**Technical circular number RDSO/2019/EL/TC/0150 (REV. '0') dated 14.3.2019**

**Sub: Proper connection of MU coupler in Microprocessor based Control & fault diagnostic System (MPCS) V3 locomotives to ensure proper working of Vigilance Control Device (VCD)**

**Ref:** ECoR letter number ECoR/EL/TRS/433/01<A>/1981 dated 10.10.2018

**Figure '2': Relevant Connection Diagram of MPCS V2**

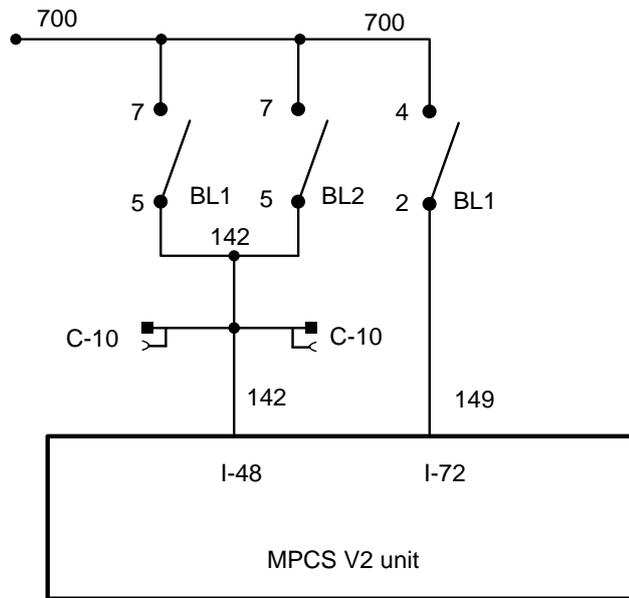
- 3.4 As per above connection diagram, input I-48 (ORed connection of BL1 & BL2) is connected to MU coupler pin number C-10 to give BL command from leading locomotive to rear locomotive during MU operation for working of control circuit. This input is available when BL1 or BL2 key is in ON position in leading locomotive.

- 3.5 Input I-72 (connected to BL1 only) is not connected to MU coupler.
- 3.6 In single locomotive operation, when HBA is switched 'ON' and BL key is in ON position, its VCD will be in active mode as per connection diagram given in figure '1'. Status of Inputs I-48 and I-72 will depend upon the cab in which BL key is made ON. If BL-1 is made ON, both I-48 and I-72 will be 'True' (or 'High' or '1') and if, BL-2 is made ON, I-48 will be 'True' (or 'High' or '1') and I-72 will be 'False' (or 'Low' or '0'). From I-48 and I-72, MPCS determines the active cab.

- 3.7 In Multiple Unit Operation, VCD of rear locomotive will be in de-active mode as per connection diagram given in figure '1'. MU Coupler pin no. C10 will become 'High' when either BL1 or BL2 is made 'ON' in leading locomotive, which will make input I-48 of trailing locomotive MPCS V2 also 'True' (or 'High' or '1'). Input I-72 of trailing locomotive MPCS V2 remains 'False' (or 'Low' or '0').

**Figure '3': Relevant Connection Diagram of MPCS V3**

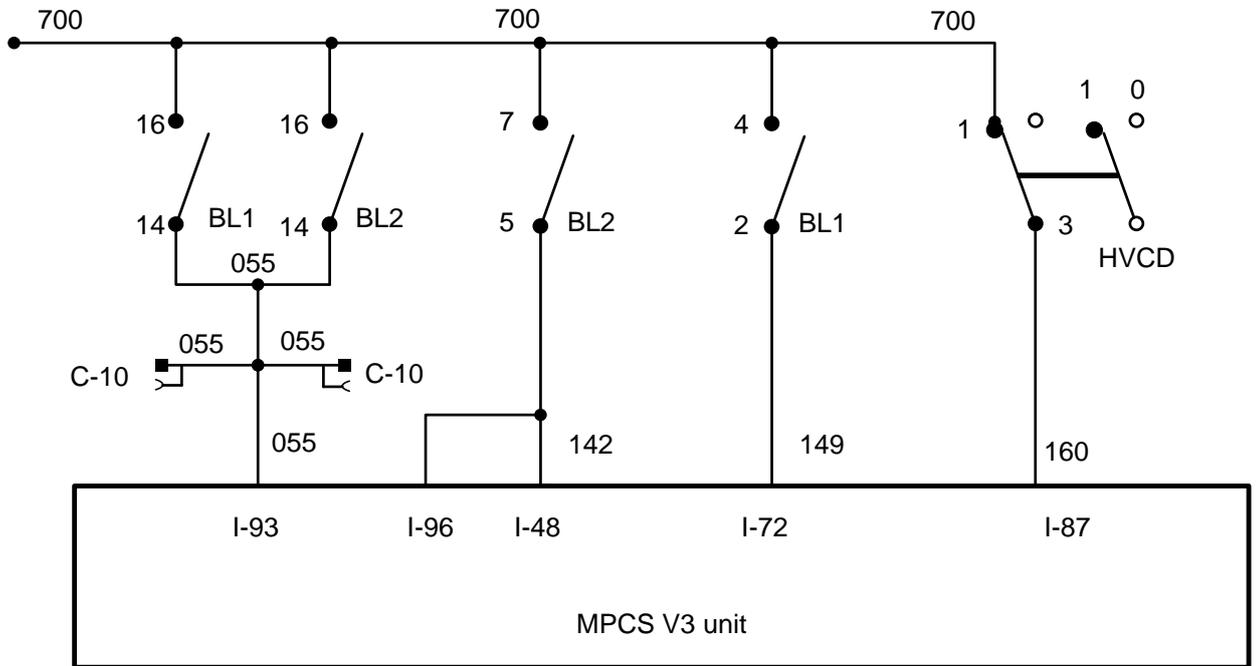
- 6.0 **Reason of VCD activation in trailing locomotive in MPCS V3 MU:**
- 6.1 As per MPCS V2 circuit, input I-48 is driven by the ORed output of BL1 and BL2 and also connected to MU coupler pin C-10.

- 6.2 However, as per MPCS V3 circuit, input I-48 is driven by BL2 alone and I-48 is not connected to MU coupler.
- 6.3 If erroneously, input I-48 is also connected to MU coupler pin C-10, in case of MU operation, in trailing locomotive, I-48 will become 'True' (or 'High' or '1') from MU coupler pin C-10 (through leading locomotive). As I-48 is input for BL2, in this case, MPCS considers that BL2 is made 'ON' in the trailing locomotive and VCD functionality is made active by the MPCS V3.

- 6.4 Probability of input I-48 being connected to MU coupler pin C-10 is high, when MPCS V3 is provided as replacement of MPCS V2 in the locomotive. As previously, locomotive was equipped with MPCS V2, as per circuit diagram of MPCS V2, input I-48 is connected to MU coupler pin C-10. However, when MPCS V3 is provided in place of MPCS V2, as per circuit diagram of MPCS V3, input I-93 is connected to MU coupler pin C-10. If connection of input I-48 which was already connected to MU coupler pin C-10 is not specifically removed, both inputs I-48 and I-93 will get connected to MU coupler pin C-10. In such cases, VCD will remain in active mode in rear locomotive in MU operation.

- 7.1 Ensure that inputs I-72, I-48, I-96 & I-93 are connected as per sheet no. 12/18 & 13/18 of DRG no. CLW.3W.15000.094 dated 05.08.2014 for WAG-7 (Modular) schematic diagram for MPCS V3 locos.
- 7.2 According to sheet no. 12/18 & 13/18 of DRG no. CLW.3W.15000.094 dated 05.08.2014 for WAG-7 (Modular) schematic diagram for Rev-3 CPU (MPCS V3), **only I-93 shall be connected to MU coupler pin no. C-10.**
- 7.3 **If any of the inputs I-72 or I-48 or I-96 is connected to any MU coupler pin, the connection should be removed.**
